# ADA Assessment Report

Town of Pittsboro, Indiana

August 17, 2015

Pittsboro A.D.A Assessment  
Report Summary – August 17, 2015

Photo #: 004  
Gas Company Office Door

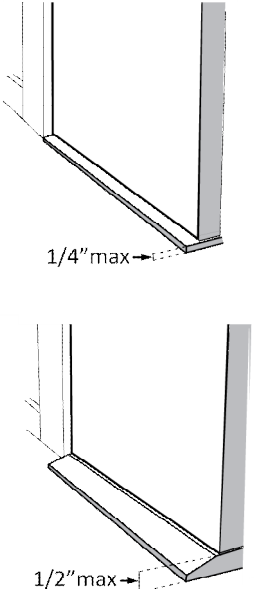
2.40 Is the door opening width at least 32 inches clear, between the face of the door and the stop, when the door is open 90 degrees?  
[404.2.3]

Measurement:  
30"

- Install offset hinges
- Alter the doorway

Photo #: 004

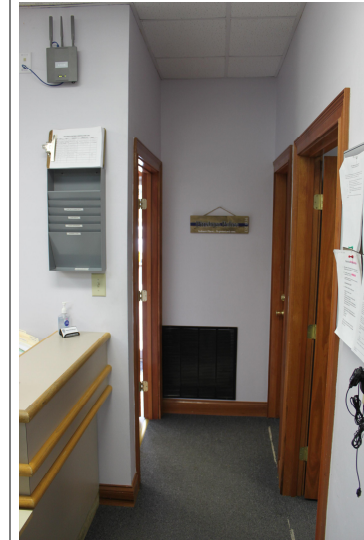
Measurement:  
35"

- Widen corridor within Police office.
- Reconfigure rear corridor between Police and Town Hall Offices to provide required corridor width and door clearances.
